REQUEST

Current Zoning: R-3 (single family residential)
Proposed Zoning: R-8(CD) (single family residential, conditional)

Approximately 4.98 acres located on the south side of Sam Neely Road, west of Steele Creek Road, and east of Krislyn Woods Place.

PLANNING STAFF REVIEW

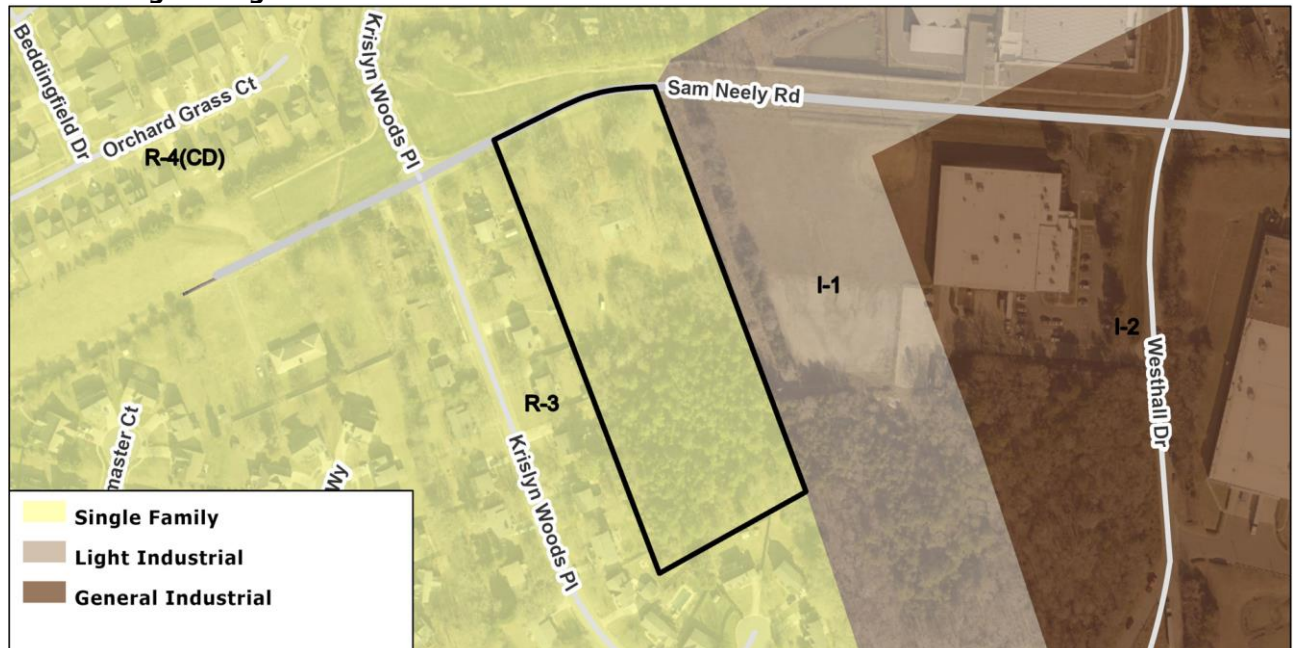
OUTSTANDING ISSUESSite and Building Design

1. ~~Adjust buffers for the site's eastern boundary to reflect a 35' Class A Buffer which can only be reduced by 25% with a berm.~~ Addressed

2. ~~Adjust tree save areas shown on the site plan to ensure compliance with the Tree Ordinance.~~ Addressed

3. ~~Adjust total number of committed parking spaces from 53 to 54 to accurately reflect the commitments of 2 spaces per unit and 6 visitor spaces.~~ Addressed

4. ~~Add open space details in note I, which are committed to on the site plan and in the Development Data Table.~~ Addressed

5. ~~Show and label the visitor spaces on the site plan.~~ Addressed
6. ~~Update conditional notes to reflect the width of the planting strip to what is shown on the site plan.~~ Addressed
7. ~~Update conditional notes to reflect the width details of both buffers to what is shown on the site plan.~~ Addressed
